BUC-EE'S #87 EL PASO COUNTY, CO
ISSUED FOR CITY SUBMITTAL
EL PASO COUNTY, CO
BUC-EE'S LTD.

DATE:	SUBMITTAL:	DESCRIPTION (SHEETS / SPECS):
2026-09-10	CITY SUBMITTAL	L000, L100, L101, L102, L103, L104, L105, L106, L107, L108, L109, L110, L111

V1_Landscape Plan drawings.pdf Markup Summary

SHEET NO.:
L110

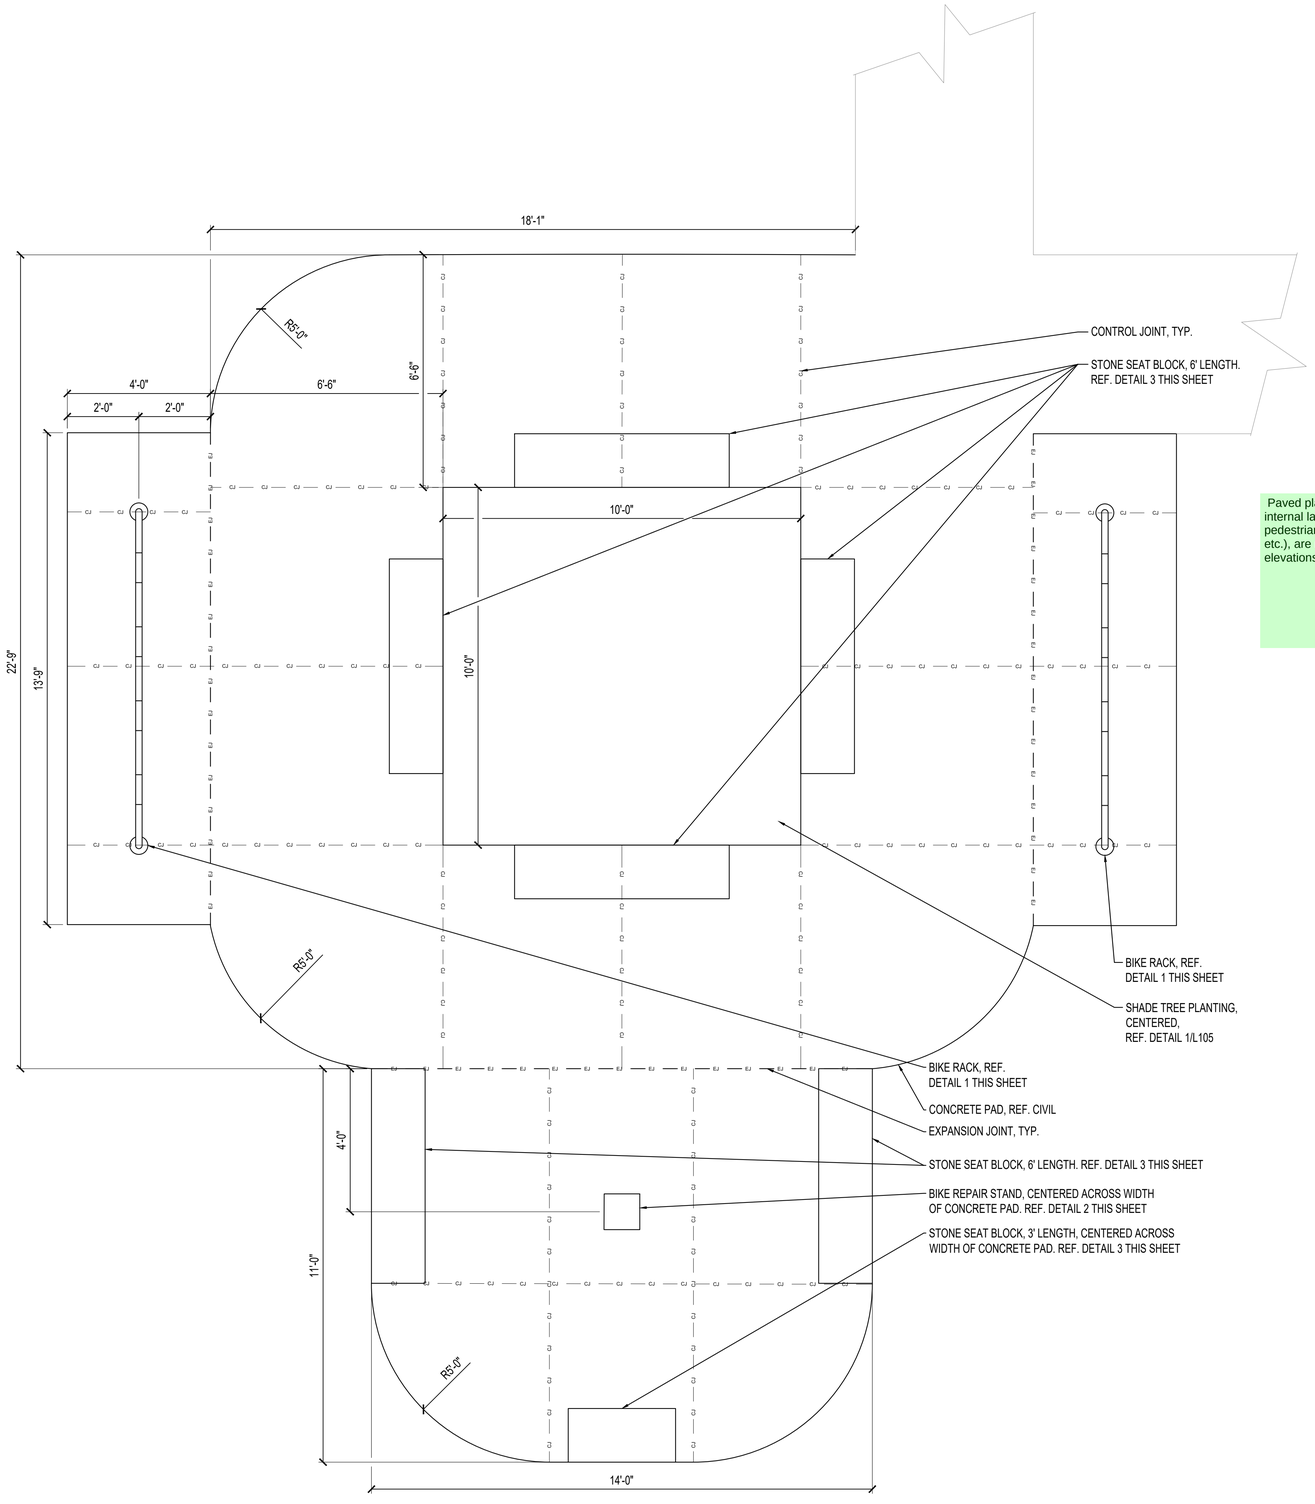
Parking lot island landscaping may also be counted towards Internal Landscape requirements provided any portion of the island is within 20 feet of a building elevation.

None of your parking lot islands are within 20 feet of the building elevation. Please provide the required 5% internal landscape.

Rural Major Collector

1 tree per 30 feet. Only 26 trees are required

Provide additional information on how the required parking lot screening is being met.

Required Parking Lot Screening. Parking lots shall be screened from view from adjacent roads and properties with differing land uses. The minimum height of the screening shall be 3 feet and may be accomplished by using berms and plantings. A minimum of ⅔ of the road frontage or common lot, parcel, or tract boundary, not counting intersecting driveways, shall be provided with the required screening. The maximum spacing of plants to achieve an acceptable screen and the maximum acceptable grades for screening areas, such as grass berms and plantings beds, should be consistent with the Landscaping and Planting Manual.
Decorative walls or fences may be approved if the Director finds that:

Provide additional information on how you are meeting the required landscape buffer and screen areas.

Required Buffer and Screen Areas. (1)Buffer Between Non-Residential and Residential Districts Separated by a Non-Arterial Road or Public Alley. (a)Where Required. A buffer is required along the road-side lot, parcel, or tract line of any non-residential use where the use is separated from a residential zoning district by a non-arterial road or public alley.(b)Depth and Planting Standards. The required buffer shall be a minimum of 15 feet deep. The minimum number of trees in the buffer shall be 1 tree for every 15 feet of the road frontage. A minimum of ⅓ of the trees shall be evergreen trees.(c)Opaque Fence or Wall Required. An opaque fence or wall with a minimum height of 6 feet is required along the inside edge of the required buffer when the area immediately adjacent to the 15-foot buffer is used as a service corridor for loading, maneuvering or storage. If the area is used for parking, the required parking lot screening shall be applicable.(d)Minimum Ground Covering Required. The required buffer area shall require a ground cover at maturity with a minimum of 75% living plant materials. Bark, wood chips, rock, stone, or other natural landscape material shall be used as a non-living ground cover. Areas of a required buffer not covered in approved living ground cover material shall be covered in an approved non-living ground cover.

Provide the amount of ground cover being proposed.

Required landscape areas shall include a minimum of 30% ground cover by living or synthetic grass or other living plant materials at maturity. The remaining 70% of the required landscape area may be covered with bark, wood chips, rock, stone, or other landscape materials. No other areas within required landscape areas shall remain bare. The foliage crown of trees shall not be counted in meeting the ground cover requirement.

Use the following tables to show how you are meeting your required landscaping

SHEET NO.:
L111

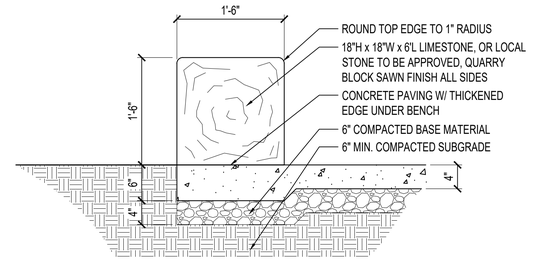
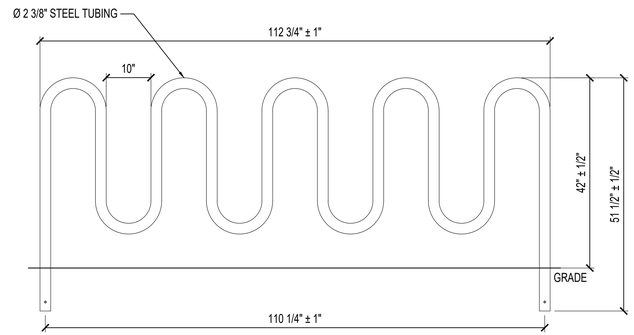
Paved plazas may be credited to a maximum of 50% of required internal landscaping area if such plazas have trees and other pedestrian-only amenities (benches, sculpture, decorative paving, etc.), are not vehicular, and provide visual relief to those building elevations which form the major public views of the project.
